**Appendix F**  
**Utility Plans and Correspondence**

## HWY 50 REGION OF PEEL --- UTILITY CONTACT LIST

**From:** Agnew, Tim  
**Sent:** Wednesday, September 07, 2011 2:02 PM  
**To:** 'nathalie.baudais@hdrinc.com'  
**Cc:** Chiu, Edward; Servera, Vinor  
**Subject:** Project #4956 - Highway 50 Road Widening

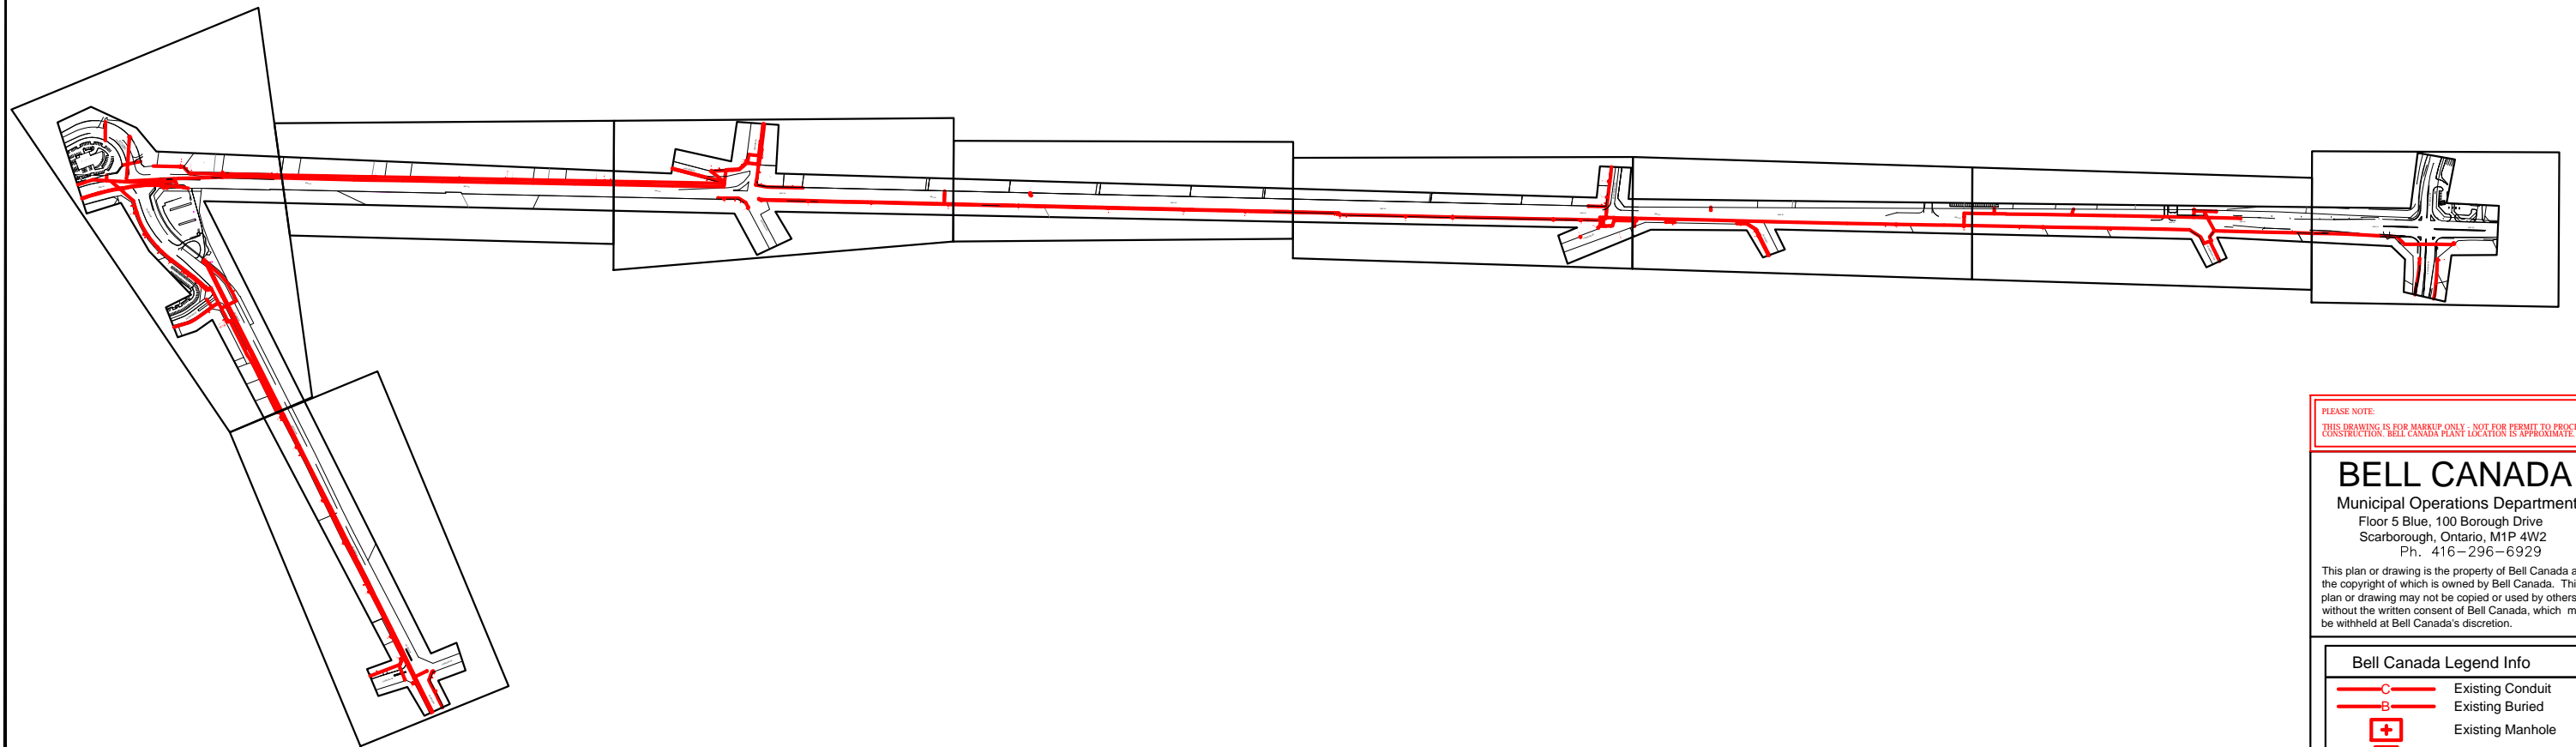
**REMARKS:** Call for locates 1.800.400.2255. Maintain clearance of 0.6m. Hand dig when crossing Bell plant.

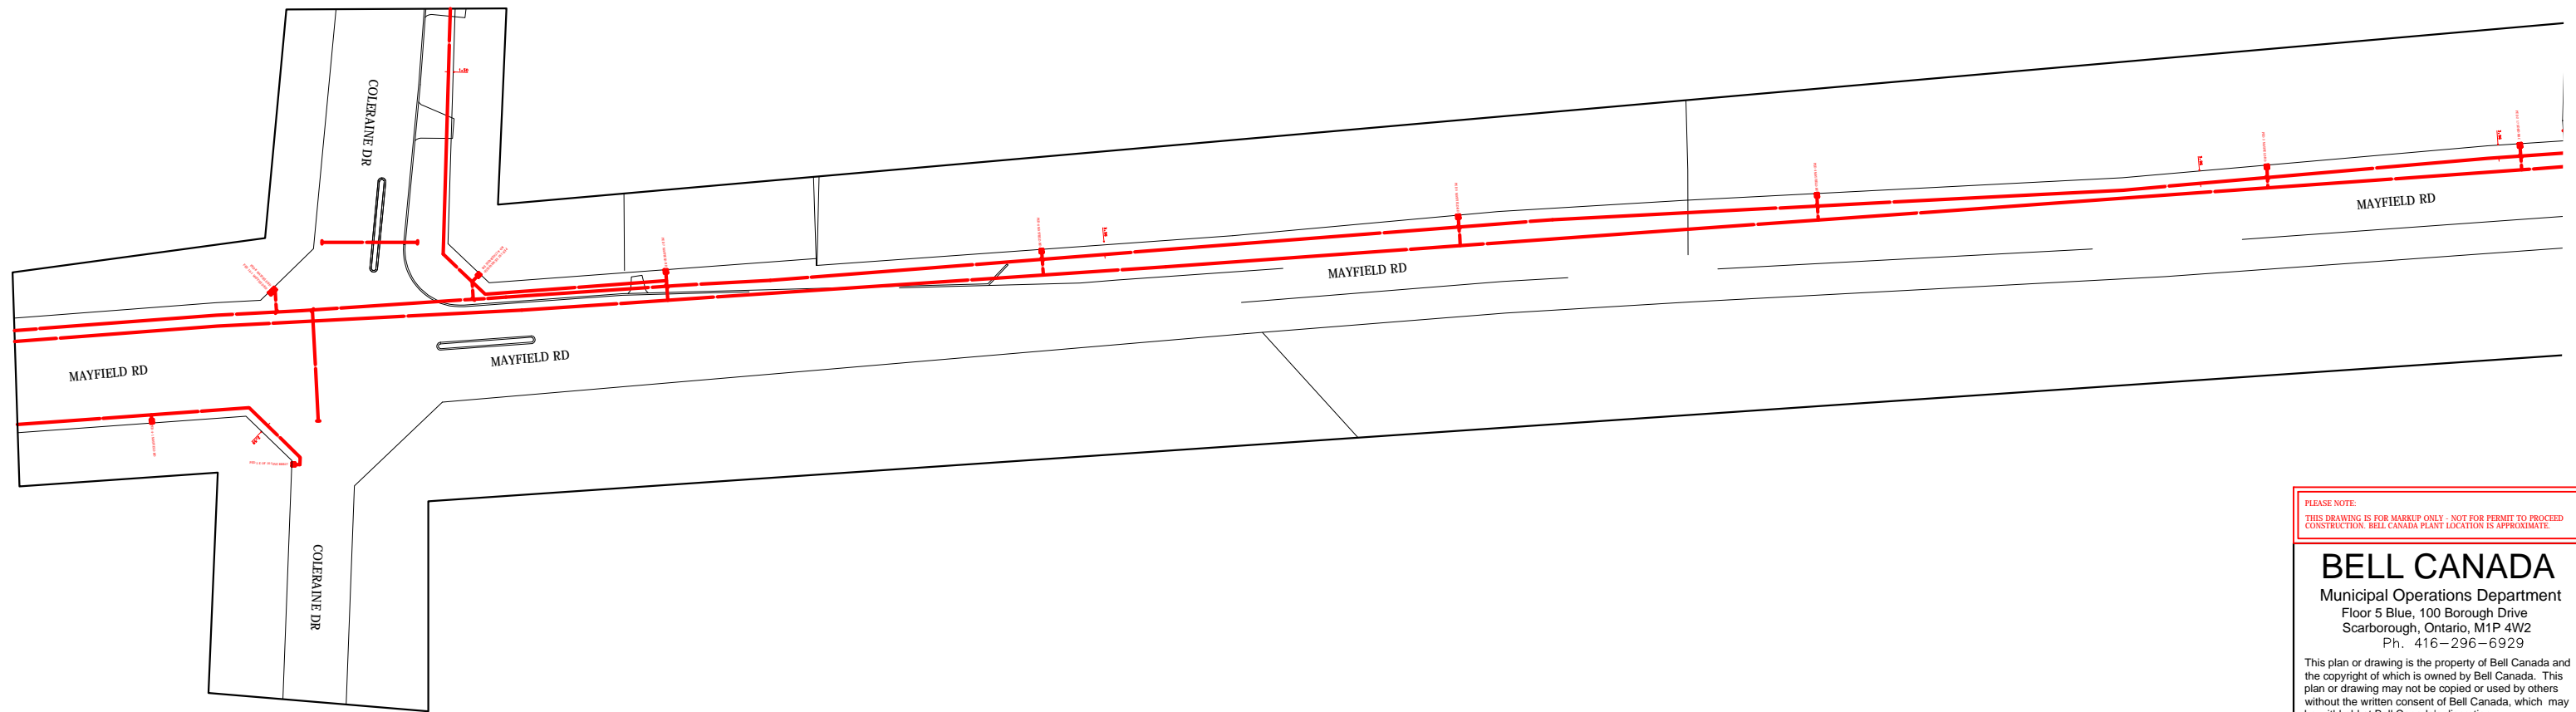
HAND DIG  
 if within 1m of Bell plant

HAND DIG  
 when crossing Bell plant

Maintain clearance of 0.6m

Dwg # - 1

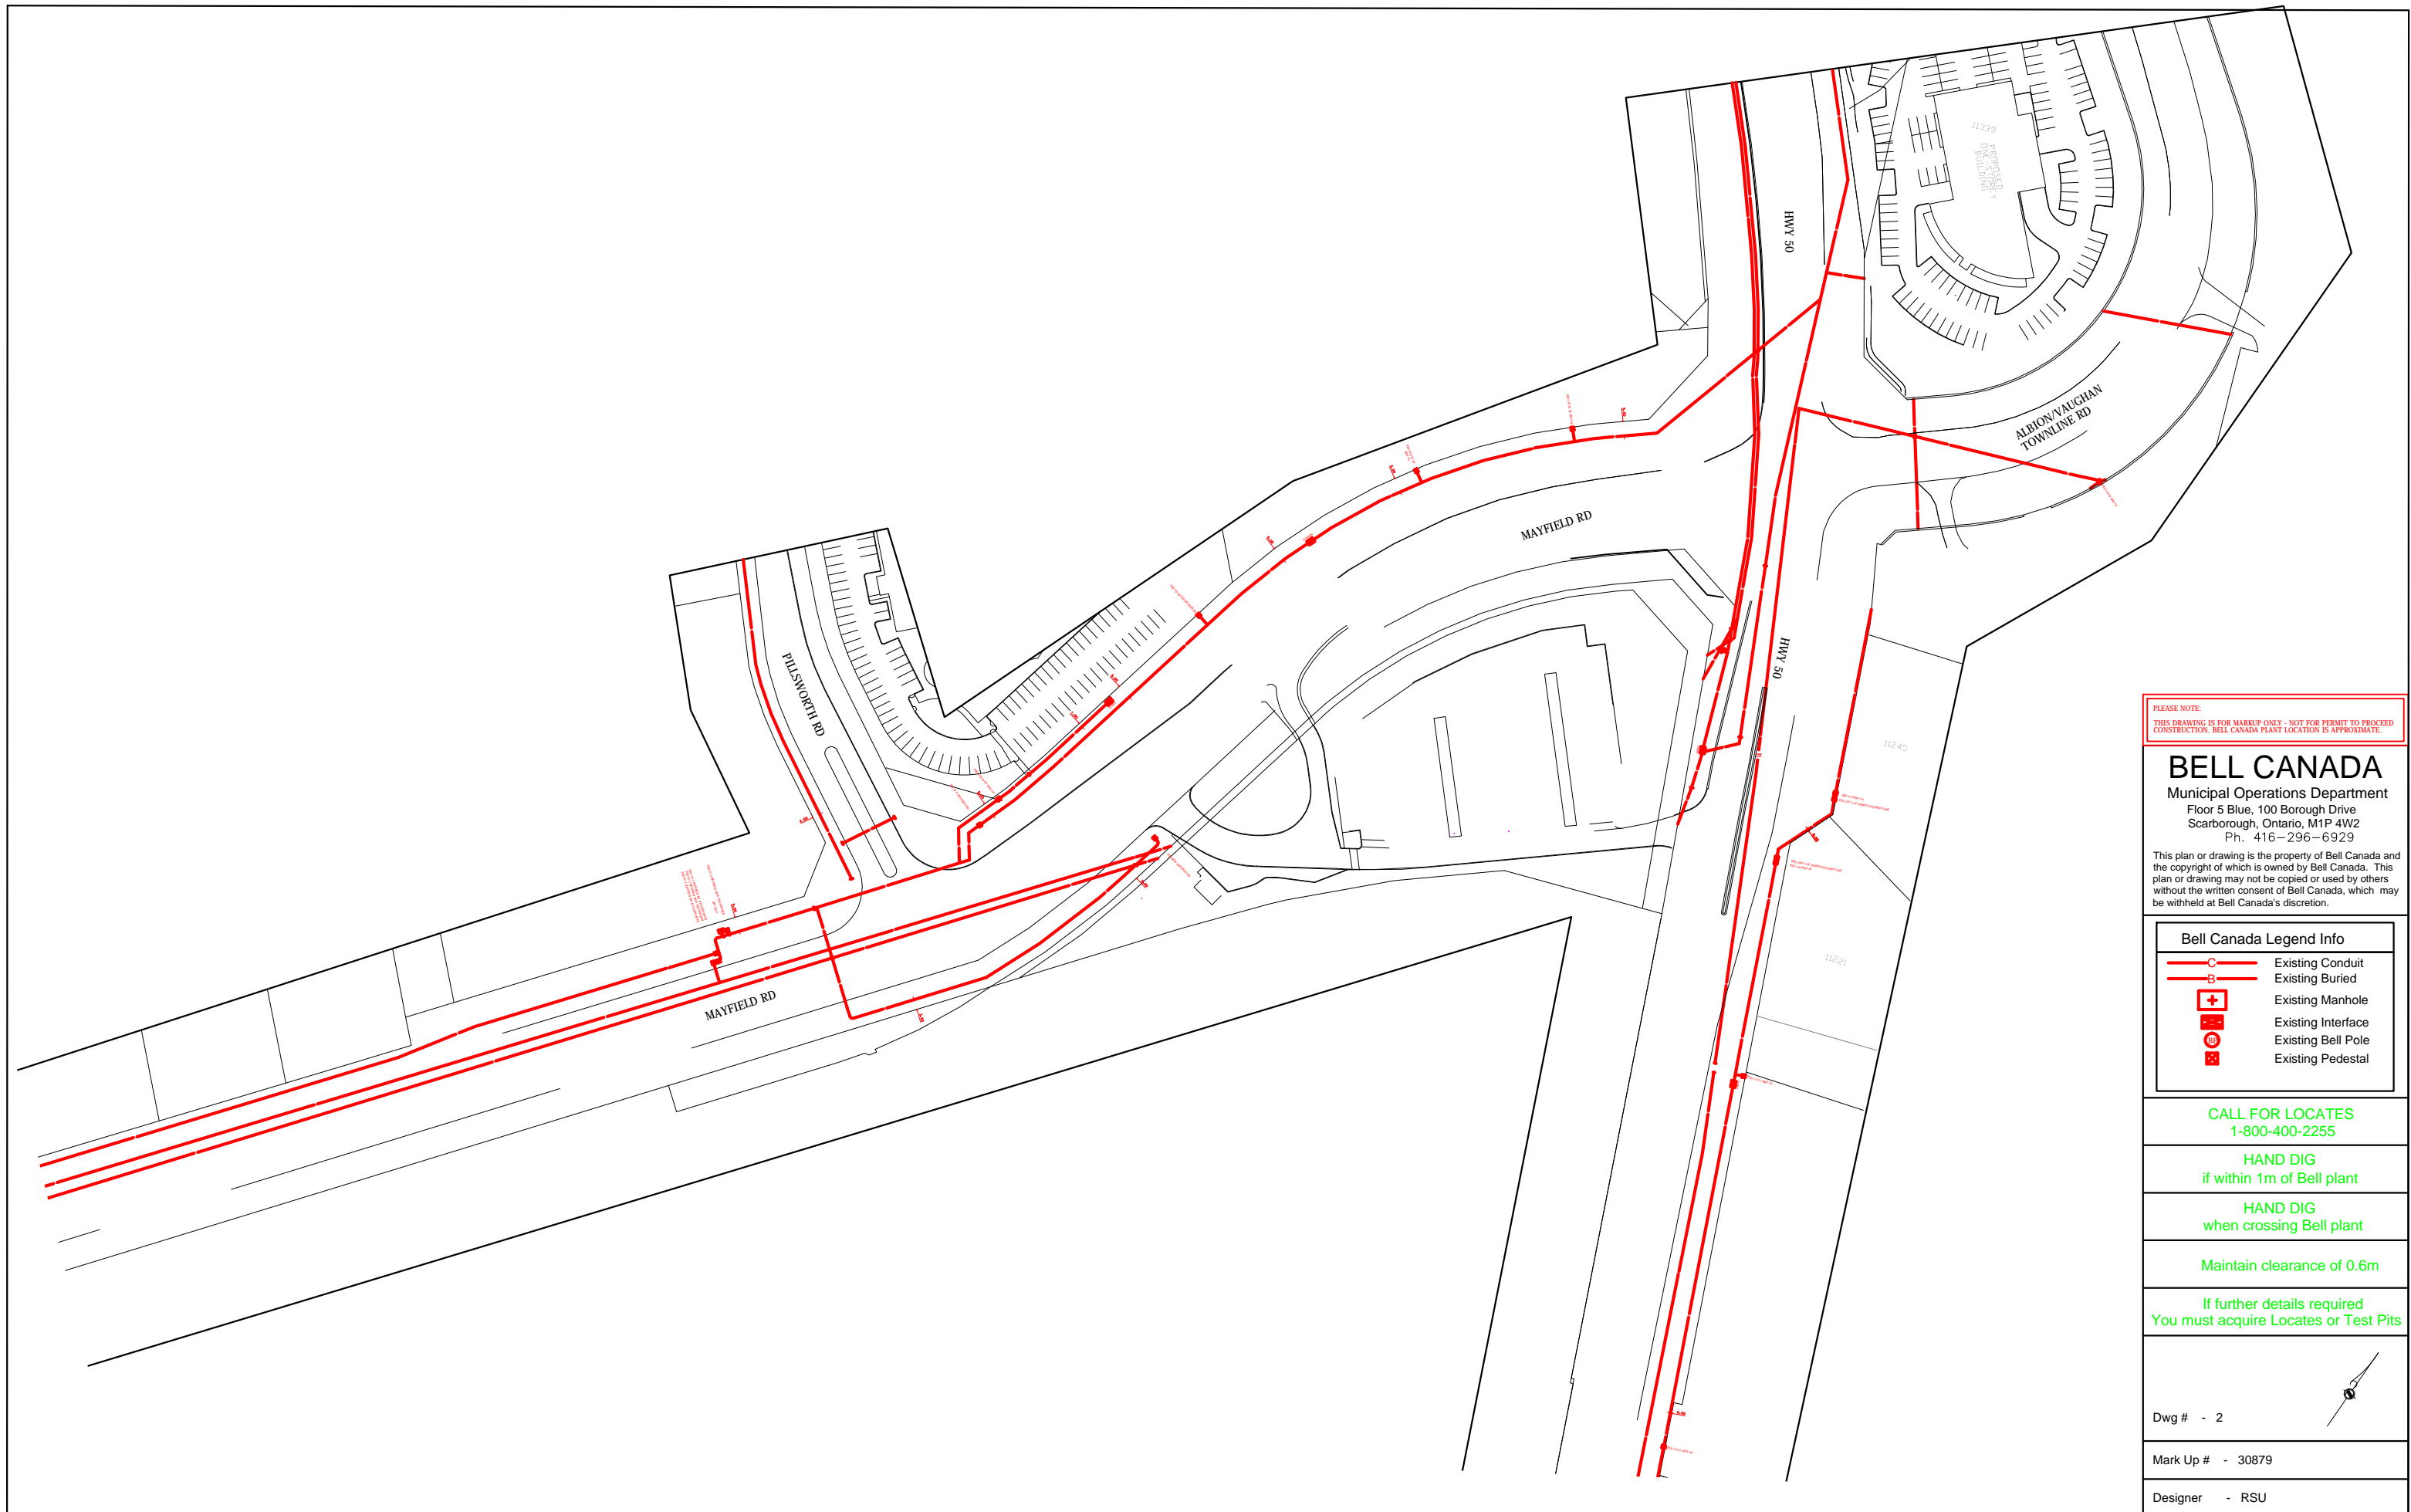
HAND DIG  
 if within 1m of Bell plant

HAND DIG  
 when crossing Bell plant

Maintain clearance of 0.6m

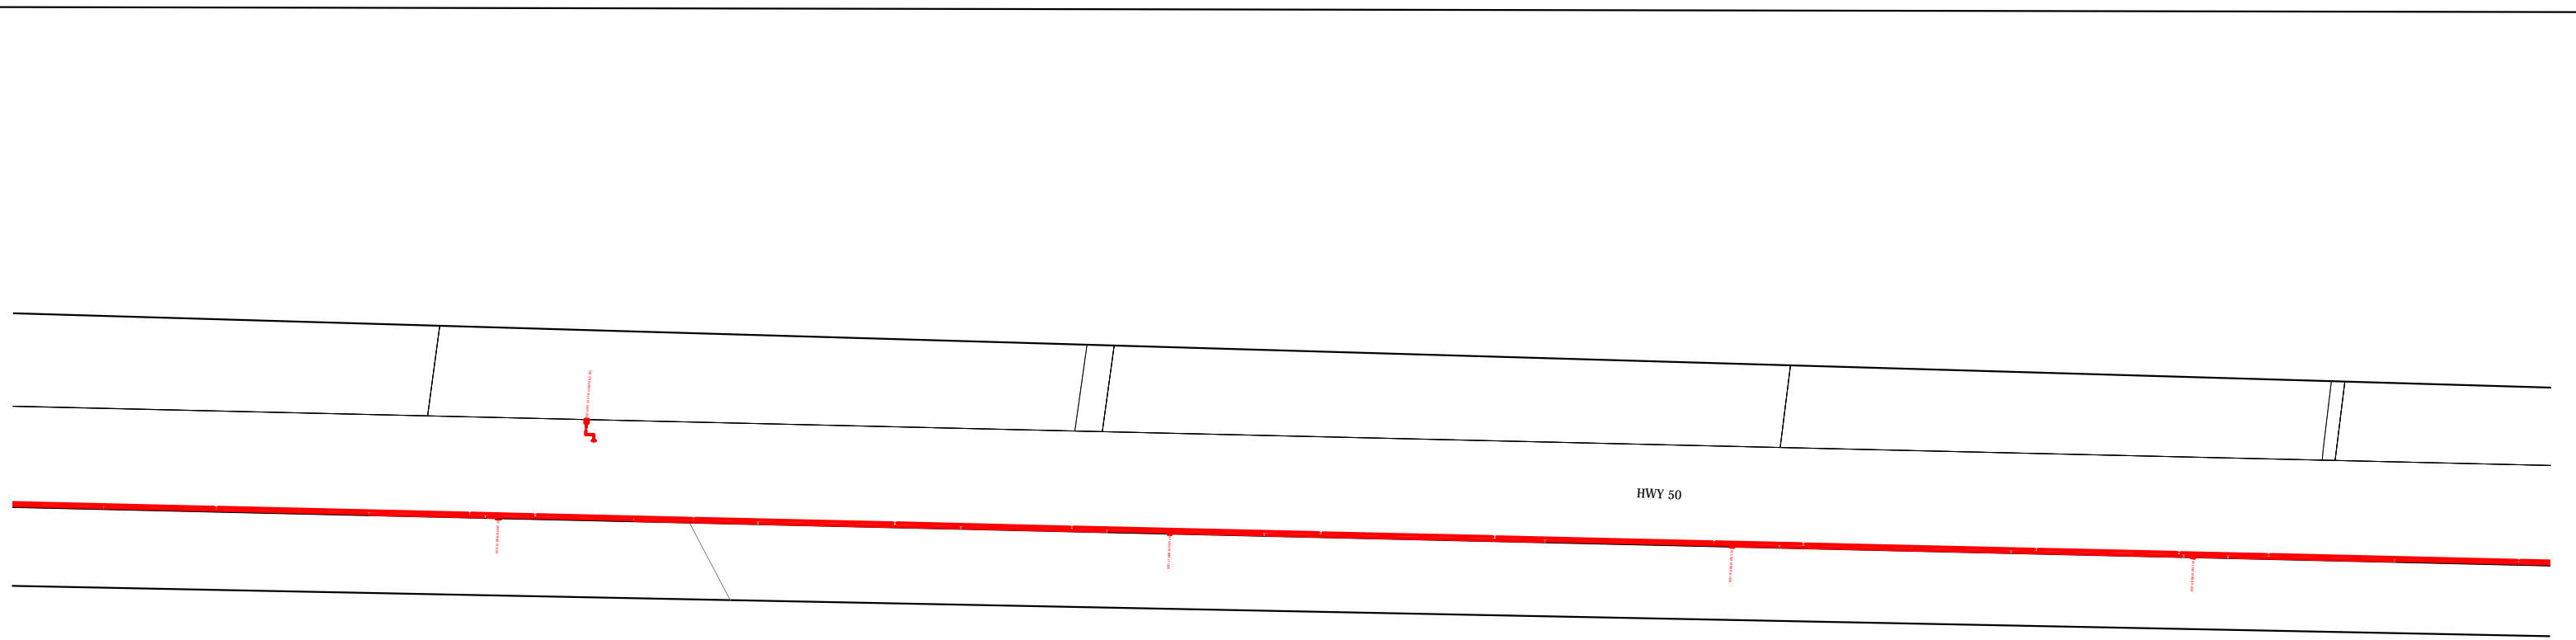
HAND DIG  
 if within 1m of Bell plant

HAND DIG  
 when crossing Bell plant

Maintain clearance of 0.6m

Dwg # - 5

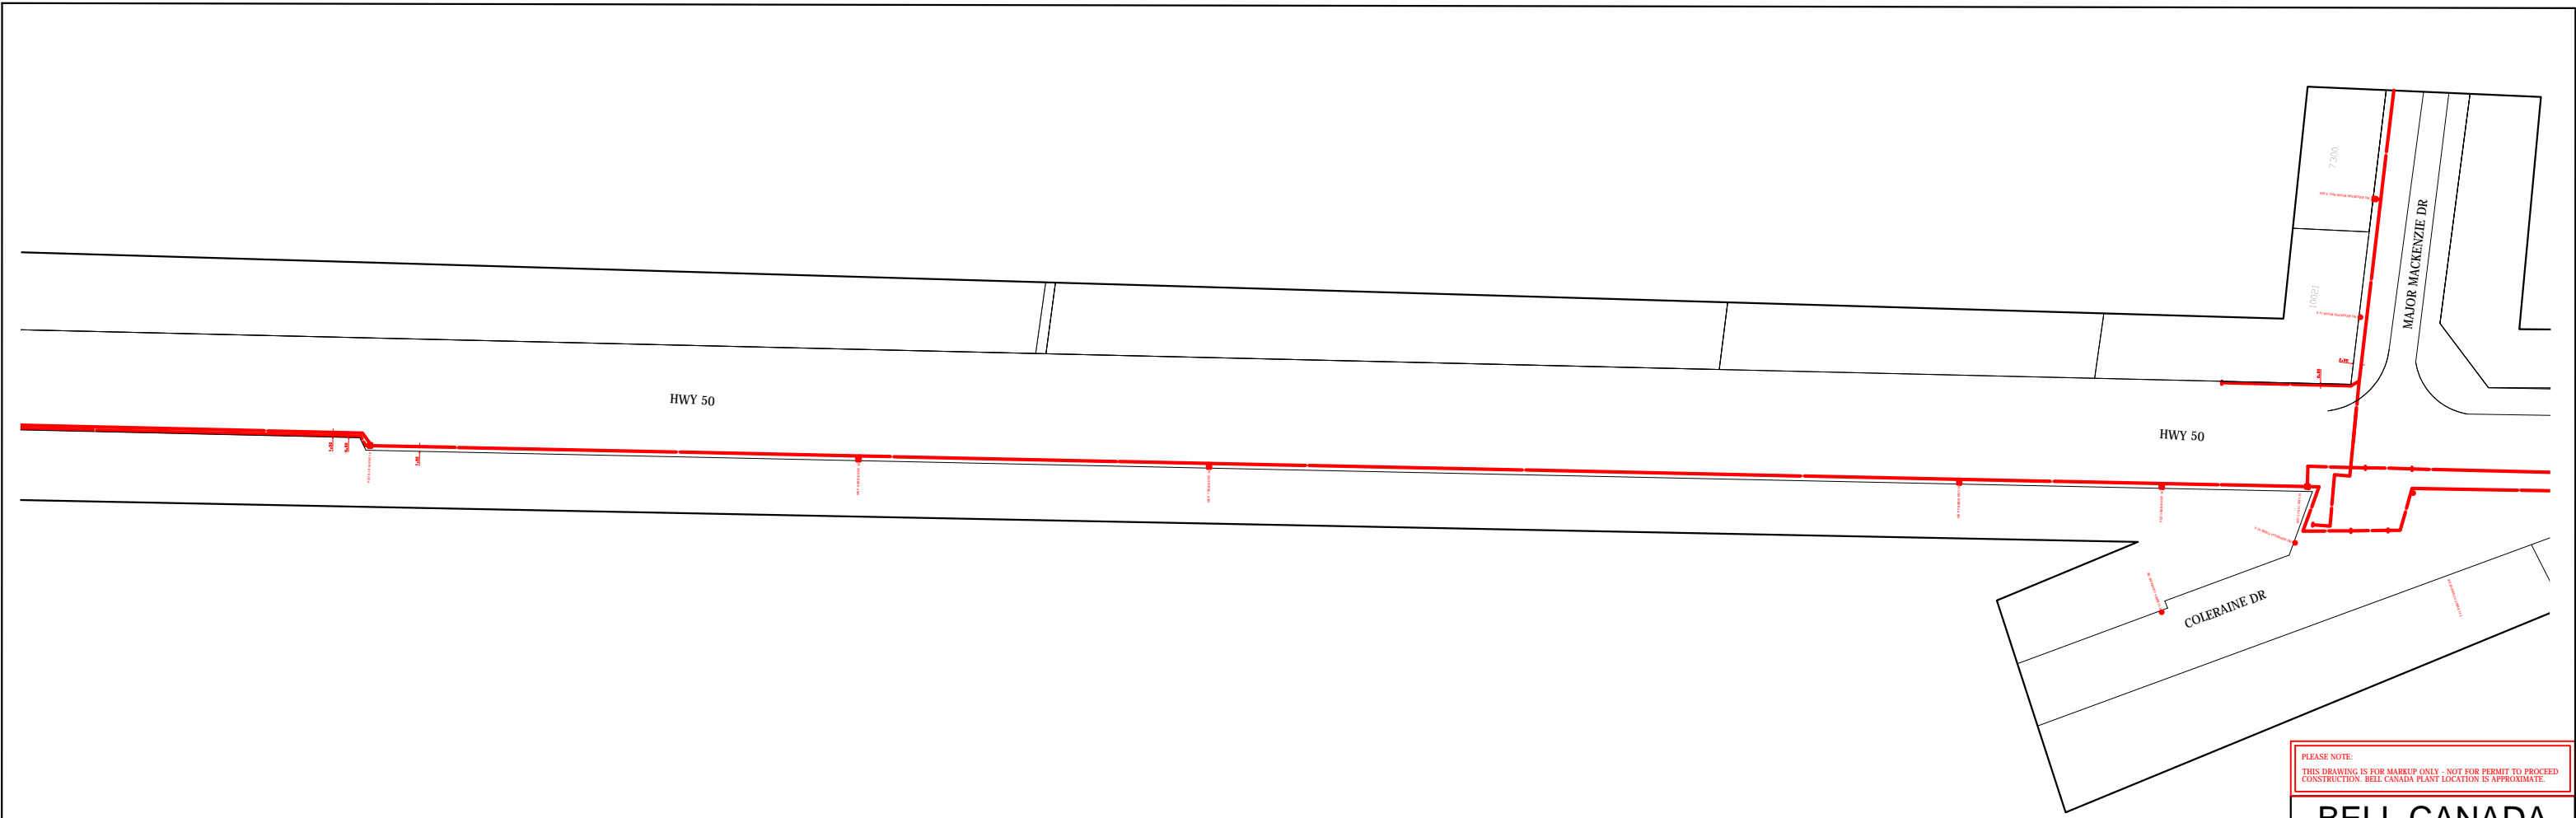
HAND DIG  
 if within 1m of Bell plant

HAND DIG  
 when crossing Bell plant

Maintain clearance of 0.6m
